**EAST COAST RAILWAY**

No. W1/162/Drg/ Policy/ 2582

**Sub: Replacement of existing Derailing Switches in directional loops with  
turnouts in connection with increasing speed to 50 Kmph.**

TYP. DRG. NO.- HQ/ 47 10 /2021

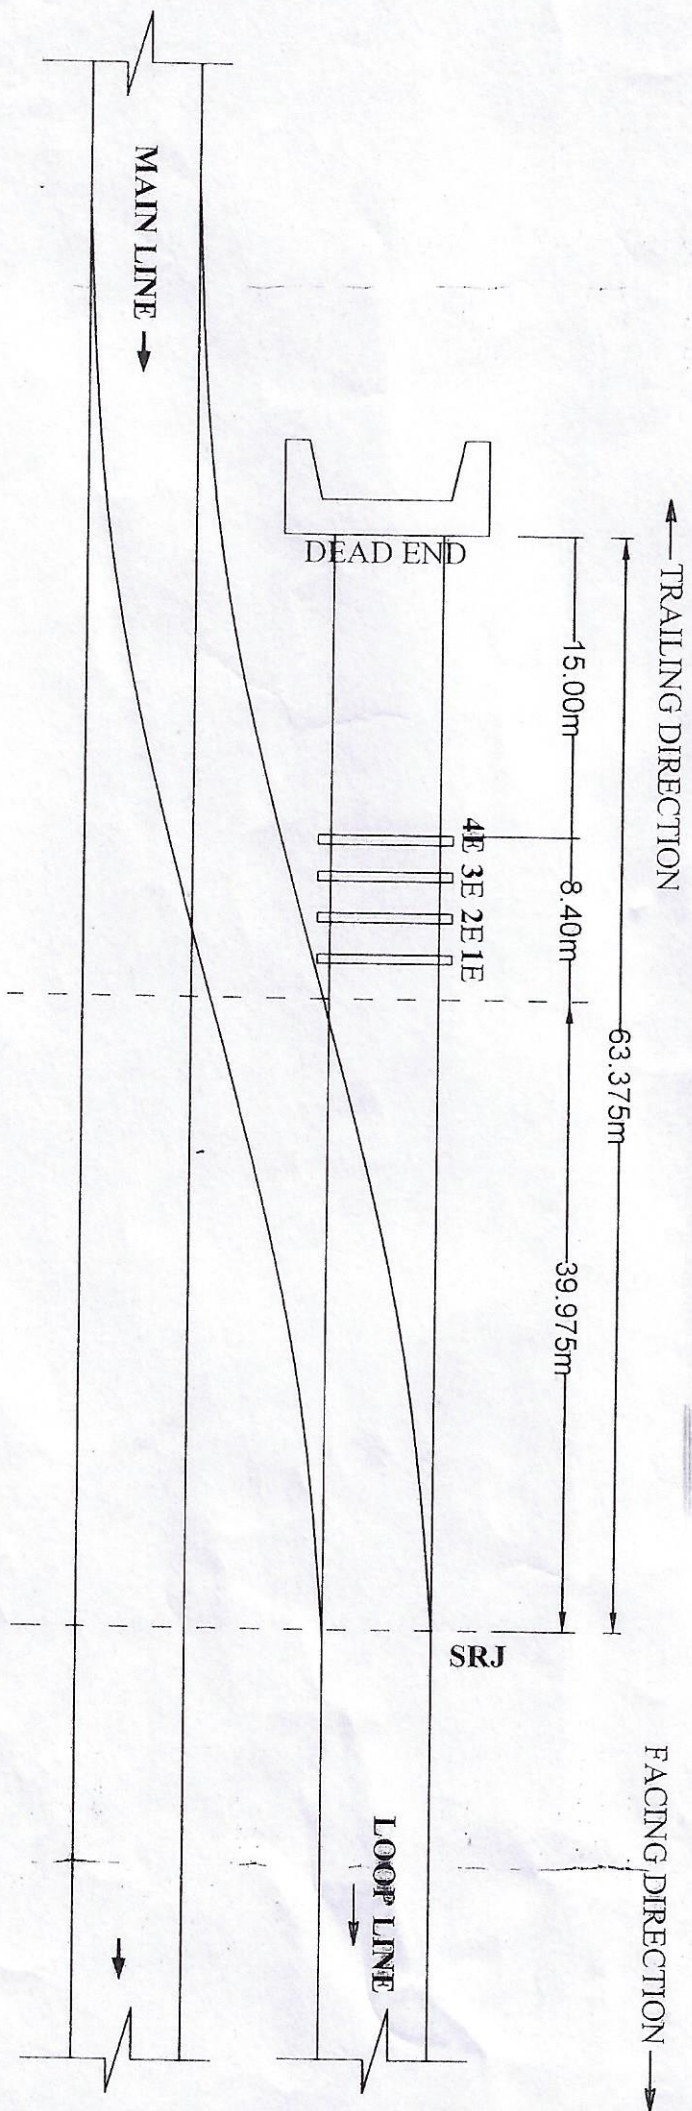
Please find enclosed herewith copy of typical drawing allotted CE's Drg. No. 4710/21 of 63.375m long over run line beyond SRJ in trailing direction crossover on loop lines is to be adopted in Zonal railways. It is for information and further necessary action at your end.

- NOTE:-
1. THE 120M OVER RUN LINE SHALL BE PROVIDED ON BOTH ENDS OF COMMON LOOP LINE.
  2. ON DIRECTIONAL LOOP IN TRAILING DIRECTION, 63.375M FROM SRJ SHALL BE PROVIDED.
